SITE PLAN

NORTH
PCD File No. CP244

THE BELLEAU RESIDENCE
6165 Waterfall Loop
COMPUTER FILE 24-2406

Sheet #
SP1
OF 1 Sheets

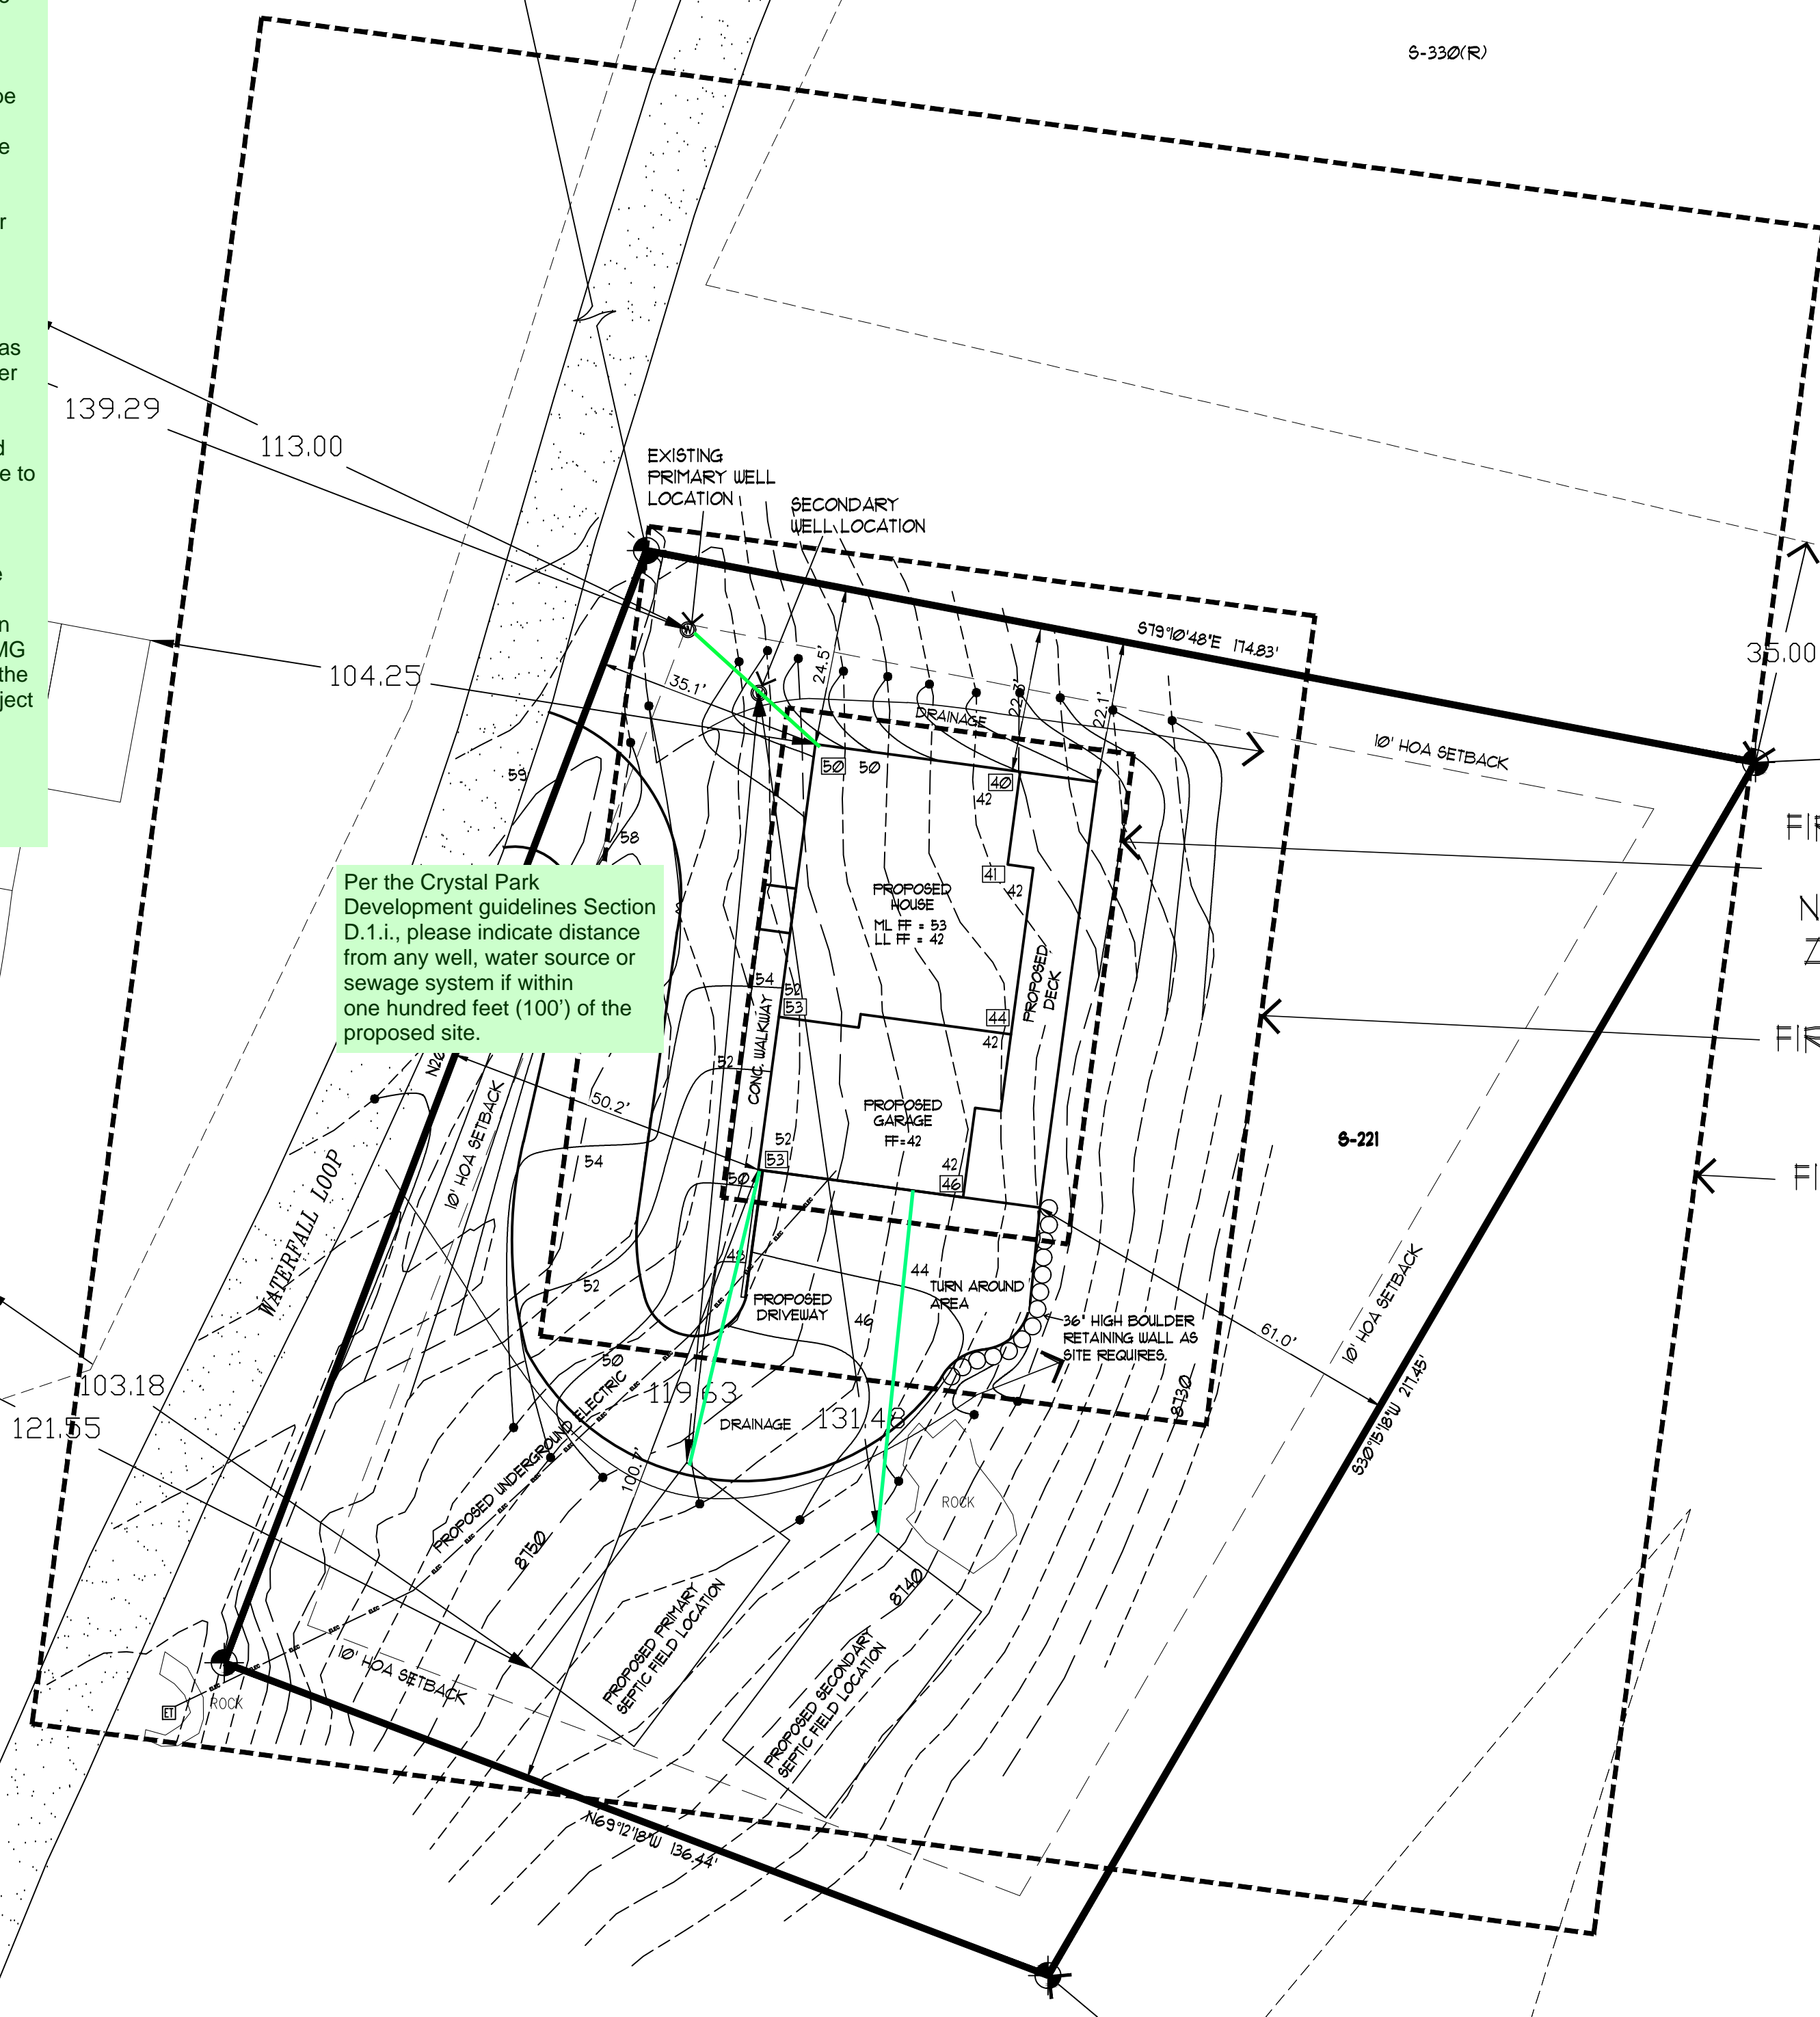
Please add the following notes to the site plan:

- The following lots have been found to be impacted by geologic hazards. Mitigation measures and a map of the hazard area can be found in the report (Title of Report, generally from the Preliminary Plan file) by (author of the report) (date of report) in file (name of file and file number) available at the El Paso County Planning and Community Development Department: *Downslope Creep: (name lots or location of area) *Rockfall Source: (name lots or location of area) *Rockfall Runout Zone: (name lots or location of area) *Potentially Seasonally High Groundwater: (name lots or location of area) *Other Hazard: In Areas of High Groundwater: Due to high groundwater in the area, all foundations shall incorporate an underground drainage system.

- A rockfall hazard is mapped west of the site and a large boulder exists south of the building area. As previously stated, the bedrock at the site is the Pikes Peak Granite, forming outcrops upslope to the west of the proposed project site. The existing rock outcrops should be examined and monitored before and during construction. Any loose rocks should be removed during construction.

- CGS agrees with RMG that (p. 6) "The structural design of the residence should consider its placement on the hillside and the additional surface pressures that could be generated by downslope creep and by retaining upslope materials," and with their recommendation, "the foundation be designed with additional rigidity to help reduce the effect of potential lateral movement of subsurface soils."

- CGS recommends that all planned cuts exceeding four feet in height be evaluated for slope stability using proposed slope geometry and considering all foundation and proposed cuts that will affect the slope. The geotechnical engineer should be provided with the construction plans and grading information to verify the proposed slopes.

- Retaining walls, building foundations, and upslope foundation walls that will function as retaining walls must be designed by a qualified geotechnical, structural, or civil engineer and include adequate behind-wall drainage.

- The site plan indicates a leach field (septic location) is planned south of the proposed residence. Engineered septic systems are commonly used in the Crystal Park area due to the steep slopes and geology.

- RMG states (p. 7), "care should be taken (both during construction and in the final grading of the lot) in redirecting surface drainage (and any resulting debris) around the structure." Site drainage should be designed and constructed to prevent concentrated flows from being developed within the site. It is imperative that water is allowed to drain quickly and NOT pond anywhere within or near developed areas. CGS agrees with RMG that "The new drainage flow path should maintain a minimum 10-foot separation from the structure." Proper maintenance and erosion protection of the slope face within the subject property is critical to the long-term structural integrity of the proposed structure.

Per the Crystal Park Development guidelines Section D.1.1., please indicate distance from any well, water source or sewage system if within one hundred feet (100') of the proposed site.

Please indicate proposed vegetation and landscaping.
